Purpose of Issue:
FOR_PLANNING

STOCKTON HOUSE STABLES

Proposed Roof Plan

| Project | No |
|---|---|
| STOCK.02 | 2001 |

1 / 2001 PROPOSED ROOF PLAN
1:50

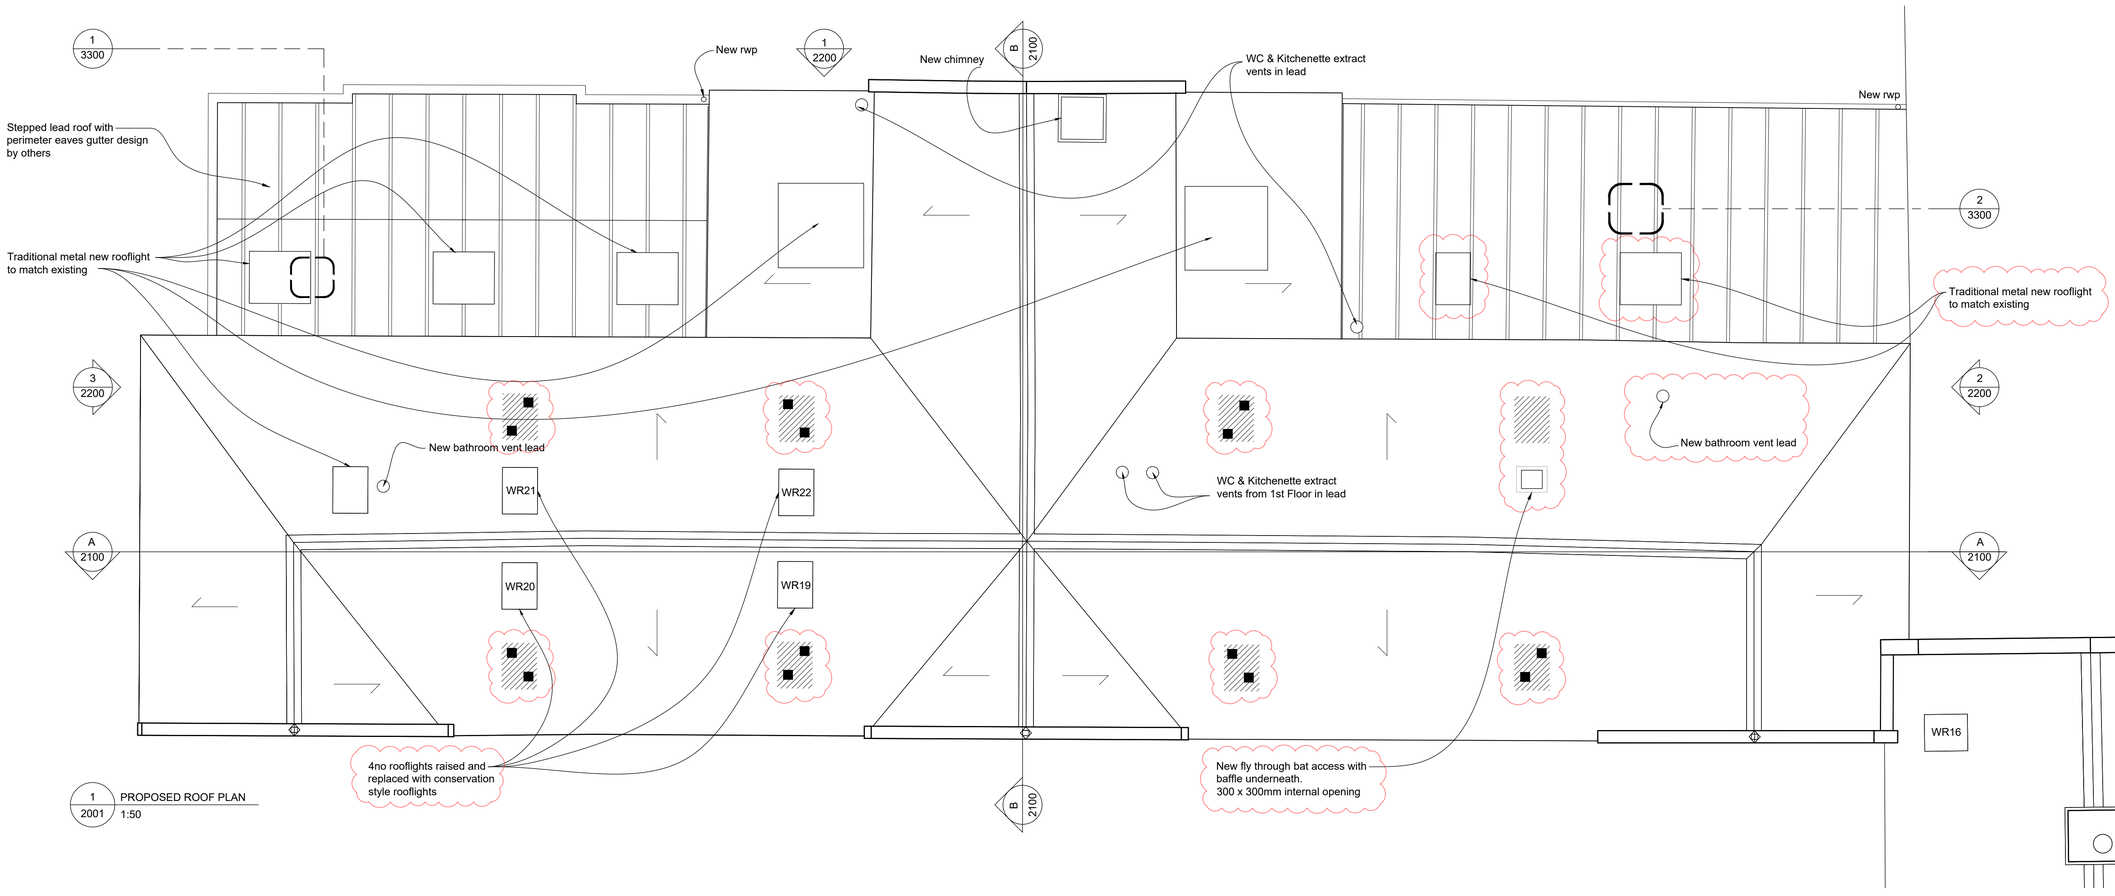
| Rev | Date | Dwn | Auth | Revision |
|---|---|---|---|---|
| 2 | 09-02-23 | SXD | LSB | 2no rooflights added to bathroom & bedroom of north east extension. |
| 1 | 02-02-23 | SXD | LSB | Bat mitigation measures added: rooflights to east side of former stables blocked, bat access tiles in previous rooflights location at east and west sides added. Fly through point to north east side added. Sun tunnel roof panel omitted and new bathroom vent lead to east side added. |

Existing rooflight blocked. Refelt roof with mineral felt or TLX bats safe breathable membrane and retile to match existing roof.

Approximate new bat access tile location
